**RE: Joint Application and Pre-Construction Notification (JA-PCN)  
Phase 2 – Modified Removal Action (MRA) – Sediment Capping Project  
SCE&G - Congaree River Sediments  
Columbia, South Carolina  
USACE Project Number: SAC-2011-01356-6NO  
Response to Comments**

CROSS SECTION OF CAPPED AREA

CONGAREE RIVER SEDIMENTS  
COLUMBIA, SOUTH CAROLINA

FIGURE 6  
SOUTH CAROLINA  
ELECTRIC & GAS COMPANY

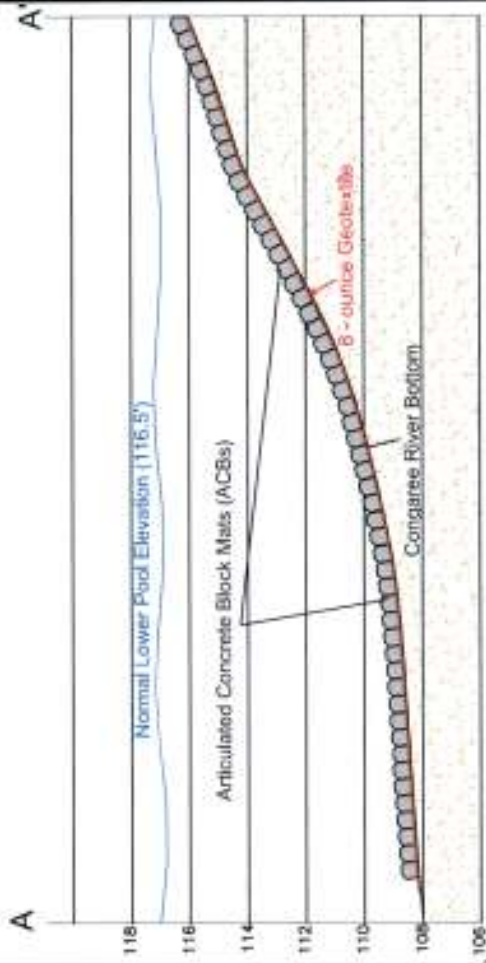
1. Are there any cross-sections in the submittal?
2. Is there any type of monitoring/contingency plan in the submittal?

Regarding the cross-sections, yes - there was one cross-section provided in Attachment B, Conceptual Design of Sediment Capping Options Developed by Rizzo and Associates, Figure 2 – ACB Mat Profile. Based on this comment, we have also developed the attached Figure 6 – Typical Cross-Section to be inserted (consecutively numbered) into the “Figures” section of the Application so as to be more prominent.
